Access Compliance Report

(Curb Ramps)

Intersection ID: 8291	Main Street: TENNESSEE_AV	Cross Street: NELSON_AV	Location: S
ADA ID: 3389EF53FC0F	Ramp Type: BlendTrans1	Initial Pass/Fail: Pass	Overall Compliance: No
		Severity Score: 5.25	
Codes/Mitigation Info/Possible Solution		Field Measurements/Component Compliance

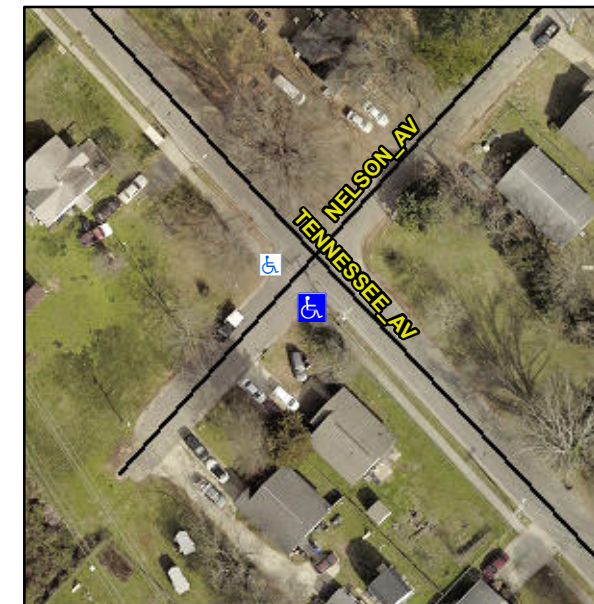
NO RT SW

Not Found, R304.5.3, R304.5.4

Compliance	Description	Data	Compliance	Description	Data
N/A	Ramp Length (in)	48.0	Yes	BlendTrans Slope (%)	4.4
Yes	Ramp Width (in)	48.0	No	BlendTrans XSlope (%)	2.9
N/A	Flare Type LT	Sloped	N/A	Flare Type RT	Sloped
N/A	Flare Slope LT (%)	4.1	N/A	Flare Slope RT (%)	0.5
N/A	Flare Traversable LT?	No	N/A	Flare Traversable RT?	No
Yes	Landing Length (in)	60.0	Yes	DWS Provided?	Yes
Yes	Landing Width (in)	51.5	Yes	DWS Contrast?	Yes
Yes	Landing Slope (%)	1.7	Yes	DWS Length (in)	24.0
No	Landing X Slope (%)	3.2	Yes	DWS Full Width?	Yes
N/A	Landing Curb? (Y/N)	No	Yes	DWS Offset (in)	1.0
N/A	Shared Landing?	No			
Yes	Gutter Ponding?	No	No	Gutter Slope (%)	11.2
Yes	Gutter Lip Ht (in)	0.0	Yes	Gutter X Slope (%)	1.4
N/A	Painted X Walk1?	No	N/A	Painted X Walk2?	N/A
	X Walk 1 Direction	To NW		X Walk 2 Direction	N/A
	X Walk 1 Width (in)	N/A		X Walk 2 Width (in)	N/A
	X Walk 1 Slope (%)	3.4		X Walk 2 Slope (%)	N/A
	X Walk 1 X Slope (%)	3.3		X Walk 2 X Slope (%)	N/A

N/A	Ramp inside XWalk1?	N/A	N/A	Ramp inside XWalk2?	N/A
	Road Slope (%)	3.3		Clear Space?	Yes
	Road X Slope (%)	3.4	N/A	Clear Space to XWalk (in)	N/A
Yes	Any Obstructions?	No	Yes	Storm Grate/Utility Hazard?	No
	Obstruction Type			Storm Grate/Utility Type	
		N/A			N/A
			Yes	Surface Condition? (G/P)	Good
			No	Curb Slope (%)	24.8

Remove & Replace Curb Ramp With Two New Directional Ramps or Equivalent. Remove & Replace Gutter.
